Service Manual

SE-VC1180

- Notes:**
- This service manual is provided to indicate the main differences between the original model No. SE-CA1080 (E) and the subsequent model No. SE-VC1180 (E, EB, EG).
 - Refer to the Connections, Quick reference of remote control operation and Preparing of the remote control of Service manual for Model No. SL-VC1180 (E), Order No. AD9506160C2.

CHANGES

A OPERATION CIRCUIT

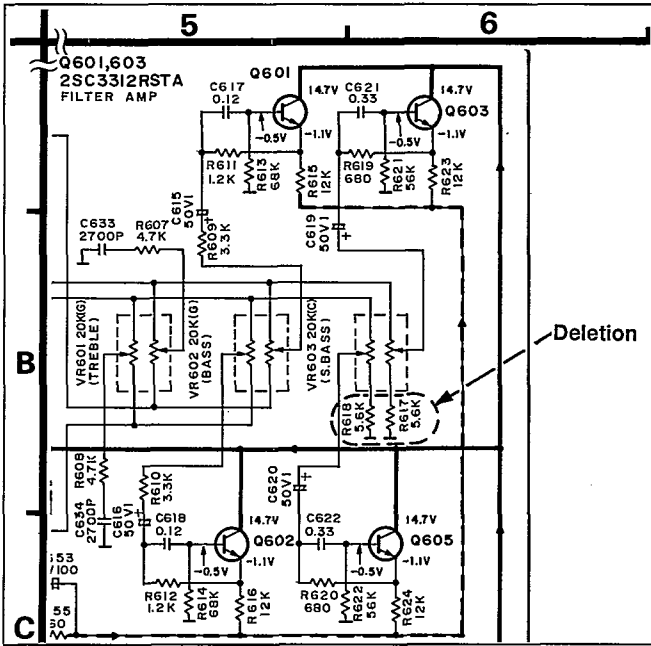
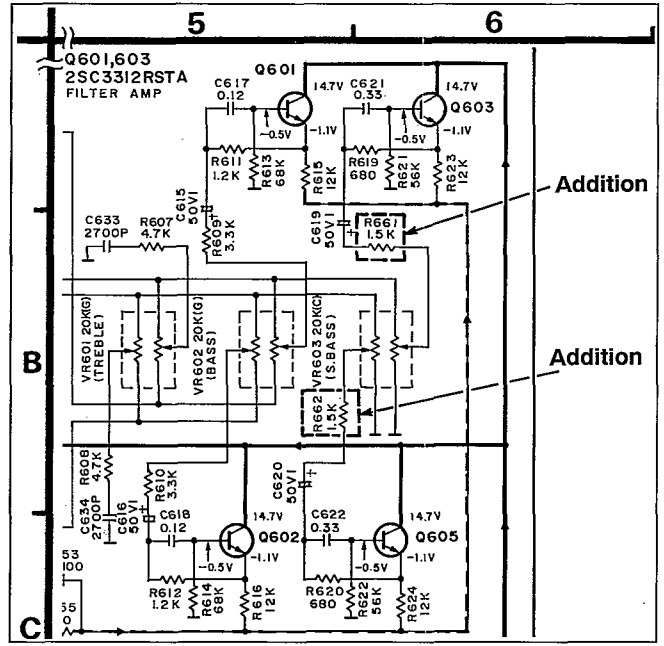
SCHEMATIC DIAGRAM (SE-CA1080 Service Manual of page 8.)

Note: Those parts have added.

A OPERATION P.C.B. (REP1924B-S)

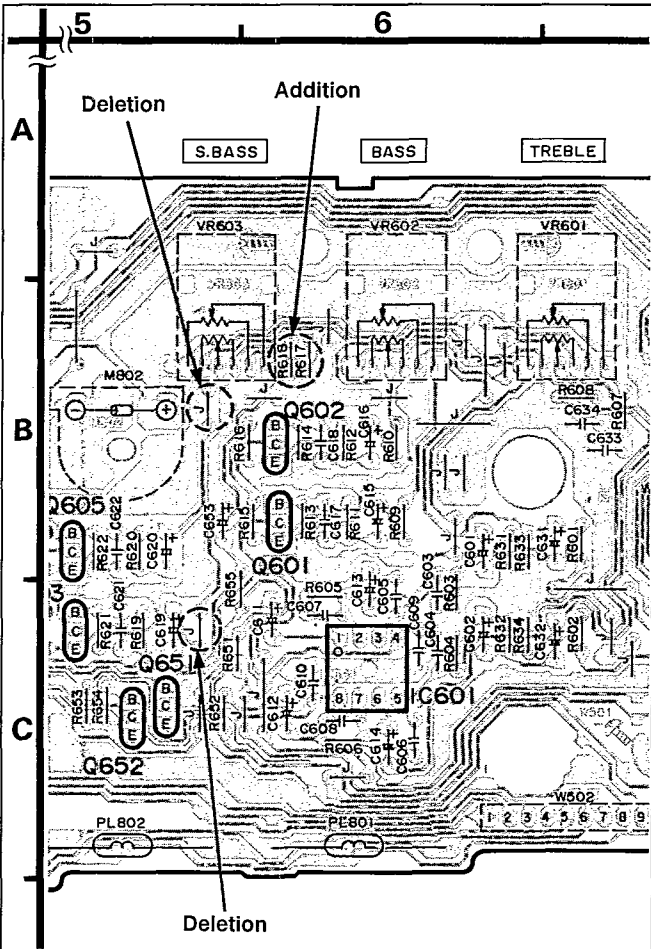
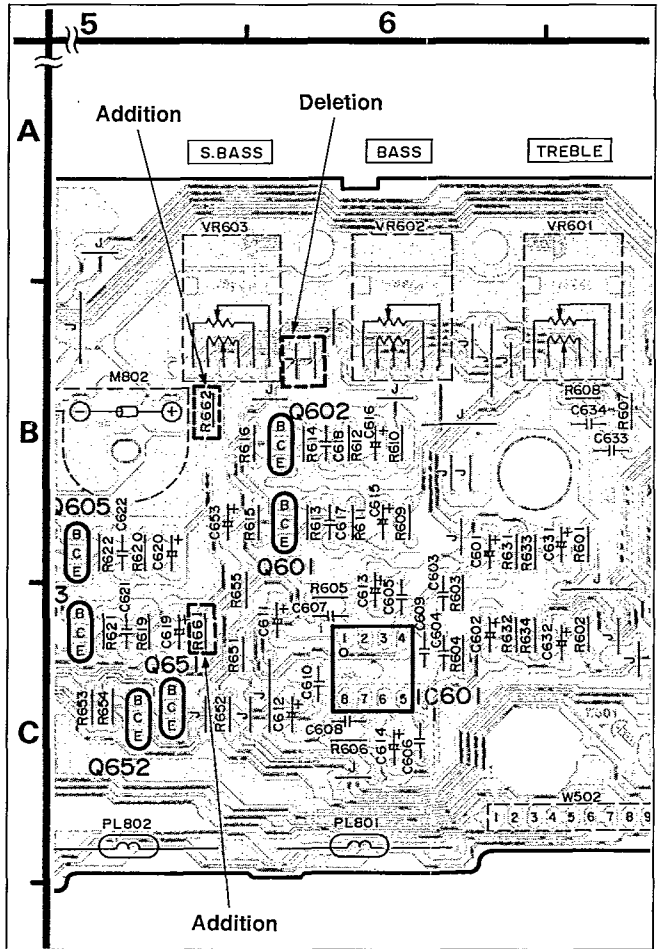
PRINTED CIRCUIT BOARDS (SE-CA1080 Service Manual of page 14.)

Note: Those parts have added.

■ CABINET PARTS LOCATION (SE-CA1080 Service Manual of page 16.)

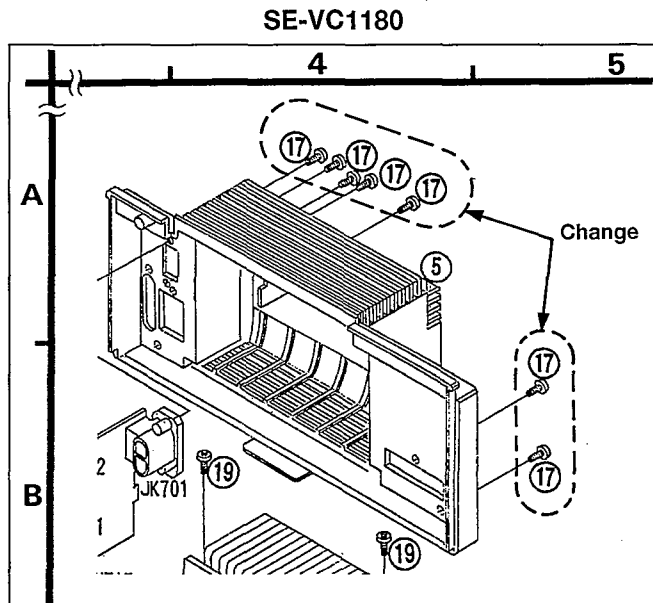
Note: Those parts have changed.
